Access Compliance Report

Public Rights-of-Way

Intersection ID: 30003	Main Street: CHEPSTOW_CT	Cross Street: KEMPSFORD_DR	Location: S
ADA ID: E5191E17259F	Ramp Type: PerpDiag	Initial Pass/Fail: Fail	Overall Compliance: No
Severity Score: 1.25			
Codes/Mitigation Info/Possible Solution		Field Measurements/Component Compliance

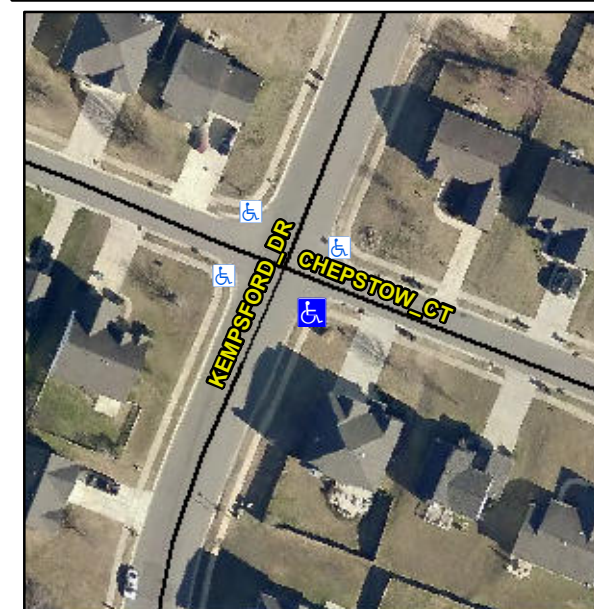
Not Found, R304.5.3

Compliance	Description	Data	Compliance	Description	Data
N/A	Ramp Length (in)	47.0	Yes	Ramp Slope (%)	5.0
Yes	Ramp Width (in)	48.0	No	Ramp XSlope (%)	3.1
N/A	Flare Type LT	N/A	N/A	Flare Type RT	N/A
N/A	Flare Slope LT (%)	N/A	N/A	Flare Slope RT (%)	N/A
N/A	Flare Traversable LT?	N/A	N/A	Flare Traversable RT?	N/A
N/A	Landing Length (in)	N/A	N/A	DWS Provided?	N/A
N/A	Landing Width (in)	N/A	N/A	DWS Contrast?	N/A
N/A	Landing Slope (%)	N/A	N/A	DWS Length (in)	N/A
N/A	Landing X Slope (%)	N/A	N/A	DWS Full Width?	N/A
N/A	Landing Curb? (Y/N)	N/A	N/A	DWS Offset (in)	N/A
N/A	Shared Landing?	N/A			
N/A	Gutter Ponding?	N/A	N/A	Gutter Slope (%)	N/A
N/A	Gutter Lip Ht (in)	N/A	N/A	Gutter X Slope (%)	N/A
N/A	Painted X Walk1?	No	N/A	Painted X Walk2?	No
	X Walk 1 Direction	To NE		X Walk 2 Direction	To NW
N/A	X Walk 1 Width (in)	N/A	N/A	X Walk 2 Width (in)	N/A
	X Walk 1 Slope (%)	1.4		X Walk 2 Slope (%)	1.3
	X Walk 1 X Slope (%)	1.3		X Walk 2 X Slope (%)	1.8

Remove & Replace Curb Ramp With Two New Directional Ramps or Equivalent.
